# LARAMIE COUNTY PLANNING & DEVELOPMENT DEPARTMENT

**TITLE:** PUBLIC HEARING regarding a Subdivision Permit & Plat for Meadowlark Airpark, located at Govt. Lots 1, 2, 3, and 4 less a portion, and all of the NW1/4 SE1/4 less a portion, Sec. 6, T.14N., R.64W., of the 6<sup>th</sup> P.M., Laramie County, WY.

**PZ-20-00330**  
**2<sup>nd</sup> Review**

**Meadowlark Airpark**

# FINAL PLAT FOR MEADOWLARK AIRPARK

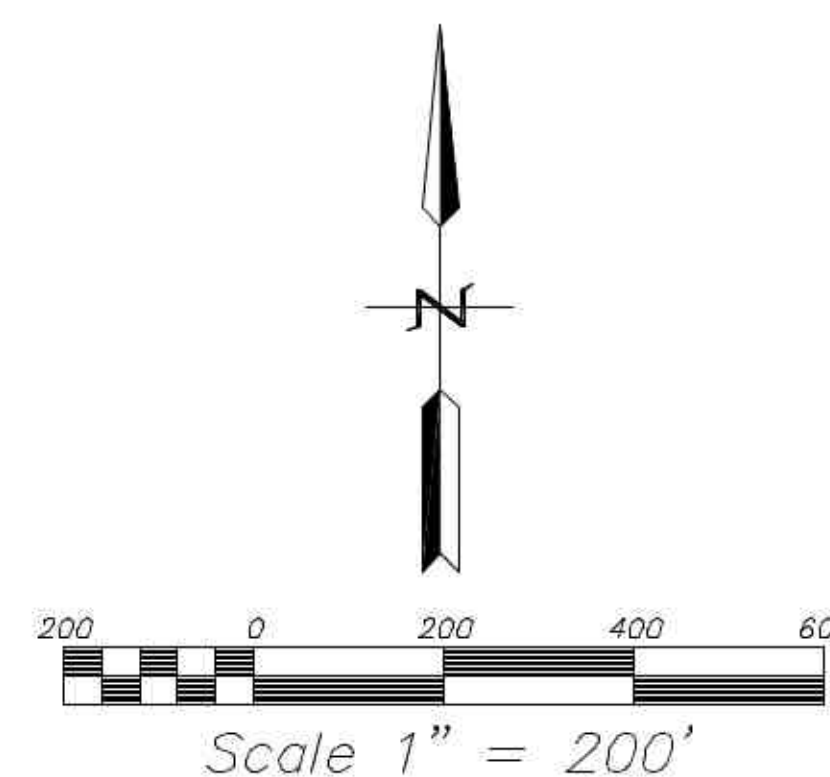
**County Assessor:** County Assessor, Kaycee Eisele Comments Attached 12/28/2020  
In the title block, Airpark is one word, which is what our records will reflect but in the dedication it is 2 words.

4. The Curve Table on the plat does not show the information for C6 and C7 that are called out on the drawing.
5. The Line Table on the plat does not show the information for L10 and L11 that are called out on the drawing.

6. The dates on the plat for approvals show 2020 and these should be changed to 2021.

1. In the first line of the last paragraph of the DEDICATION "HAS" should be "HAVE", in the second line of the same paragraph "THERE" should be "THEIR" and in the third line of the same paragraph "THERE" should be "THEIR".

2. The dimension arrow indicating the north boundary of SKY TRAIN COURT, shown along the south boundary of TRACT 2, is drawn/connected to the north boundary of the 10' UTILITY EASEMENT, not to the north boundary of SKY TRAIN COURT.
3. Along the east boundary of TRACT 4, the text identifying the 40' ACCESS EASEMENT is overlapping the dimension of the east boundary of TRACT 4.
4. What is the purpose/function of the "WEST 80' SECTION 5-BOOK 955, PAGE 541" labeled east of the southeast corner of TRACT 20?

1. In the first and fourth paragraphs of the dedication, the subdivision is referred to as "Meadowlark Air Park", but in the title is is referred to "Meadowlark Airpark". Please revise.
2. The third paragraph of the dedication should also be updated to say "Said parcels" not "Said parcel".
3. The approval blocks must be placed directly next to the right or bottom border of the plat.
4. Approval Dates in the signature blocks must be updated to read 2021 rather than

5. Please label the property directly to the east of proposed tracts 24-27 as unplatted for continuity purposes.

6. Please add a note stated that the proposed roads will be privately maintained and will not be maintained by Laramie County.

7. Please update the Curve and Line Tables to show all Curve #'s and Line #'s as some are missing.

8. The acknowledgments signatures block will be signed in 2021, please update year.
